RANGELINE CROSSING SUBDIVISION

APPLICATION NUMBER 4 DATE March 20, 2014

REQUEST Subdivision

DETAIL SITE PLAN

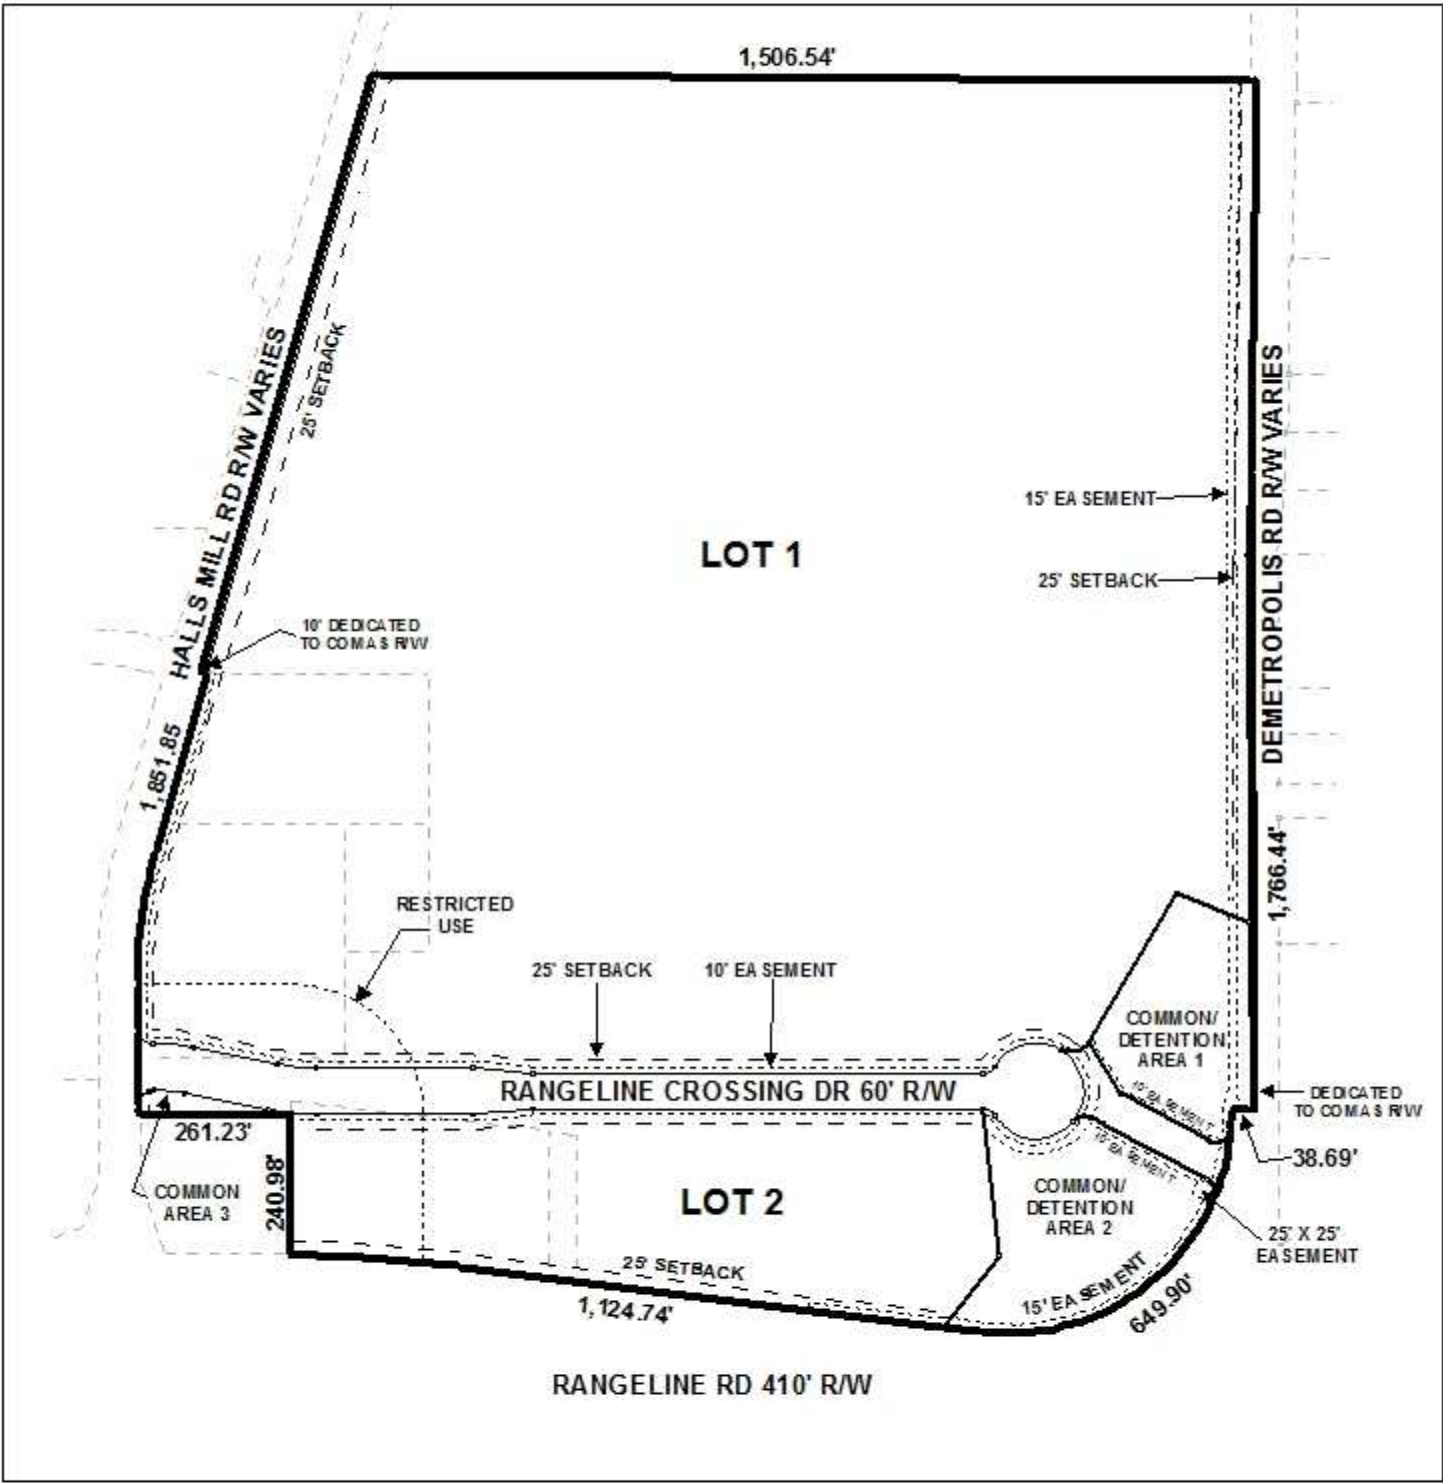
Engineering Comments: The following comments should be addressed prior to acceptance and signature by the City Engineer: A. Provide additional line weight to the exterior boundary lines and the metes and bounds labels of the proposed subdivision. B. Revise the west end of the north line of the proposed 60 ft. ROW between Common Area No. 1 and No. 2. Maintain a constant 60 foot width by removing the proposed 100.82' long segment and curve C22 (or as approved by the City Engineer and Traffic Engineer). C. Provide the Surveyor's Certificate and Signature. D. Provide the Surveyor's, Owner's (notarized), Planning Commission, and Traffic Engineering signatures. E. Add a note that sidewalk is required to be constructed along the frontage of each lot, or parcel, at time of development, and, along each common area with the construction of the subdivision roadway, unless a sidewalk waiver is approved.

A proposed internal street with a minimum 60' right-of-way is indicated on the plat with a cul-de-sac terminus exceeding the minimum radius of 60' as required by Section V.B.14. of the Subdivision Regulations. As the street is over 600' in length, a waiver of Section V.B.6. of the Subdivision Regulations would be required. The proposed street would need to be constructed to City standards prior to signing of the Final Plat.

The plat illustrates the 25' minimum building setback line along Demetropolis Road as measured from the required frontage dedication. However, there is a 15' water and sewer easement slightly further within the property along that street frontage. Therefore, the plat should be revised to illustrate a minimum building setback line along Demetropolis Road as necessary to also include this easement and measured from the required dedication. As shown in other areas of the site, the 25' minimum building setback line should also be illustrated along all street frontages as measured from any required right-of-way dedication. The plat should be revised to also illustrate the 25' minimum building setback line along the future right-of-way connection between the cul-de-sac and the Demetropolis Road/Rangeline Road intersection.

- 4) construction of the internal street to City standards prior to signing the Final Plat;
- 5) revision of the plat to illustrate a minimum building setback line along Demetropolis Road as necessary to also include the 15' water and sewer easement and measured from any required dedication;

- 6) illustration of the 25' minimum building setback line along all street frontages as measured from any required right-of-way dedication;
- 7) revision of the plat to illustrate a 25' minimum building setback line along the future right-of-way connection between the cul-de-sac and the Demetropolis Road/Rangeline Road intersection;
